Technical Service Bulletin (TSB)
Global Telematics Box Module (TBM)
Firmware Over The Air (FOTA) Update

REFERENCE:	TSB: 08-199-26 GROUP: 08 - Electrical	Date:	May 2, 2026	REVISION:	–
VEHICLES AFFECTED:	2026 (WS) Jeep Wagoneer / Grand Wagoneer This bulletin applies to vehicles built on or before January 22, 2026 (MDH 0122XX) equipped with Global Telematics Box Module (Sales Code RDG).			MARKET APPLICABILITY: ☒ NA☐ MEA ☐ SA☐ IAP ☐ EE☐ CH NOTE: This bulletin applies to the North America market.	
CUSTOMER SYMPTOM:	Customers must experience a Malfunction Indicator Lamp (MIL) illumination and the vehicle must exhibit/set one or more of the following Diagnostic Trouble Codes (DTCs): - B22A9-96 ECU Internal Performance-Component Internal Failure. - B1560-11 Cellular Antenna 1 - Short To Ground. - B1560-13 Cellular Antenna 1 - Circuit Open. - B1561-11 Cellular Antenna 2 - Short To Ground. - B1561-13 Cellular Antenna 2 - Circuit Open. - B1562-14 GPS Antenna Short To Ground Or Open. Customers may also experience the following: "Uconnect Box Required Service" message in Radio Display.

**Fig. 1**

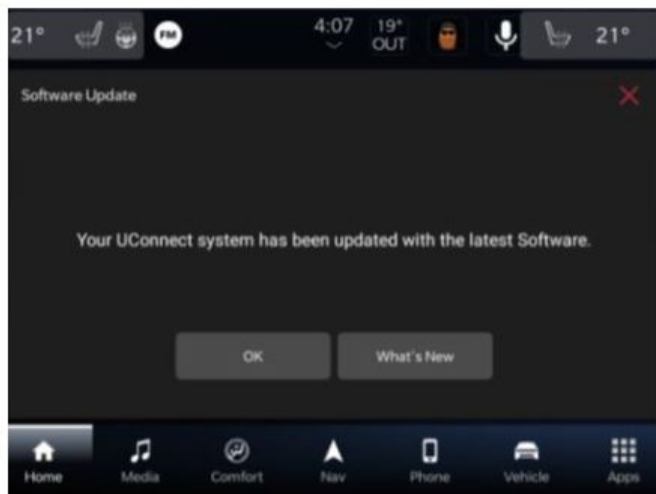
1. The vehicle needs to be in 'Park'. The ignition needs to be in the off position.
2. If the customer selects "Update Now" [Fig. 2](#) they can shut off the vehicle and leave. The update will be completed automatically.
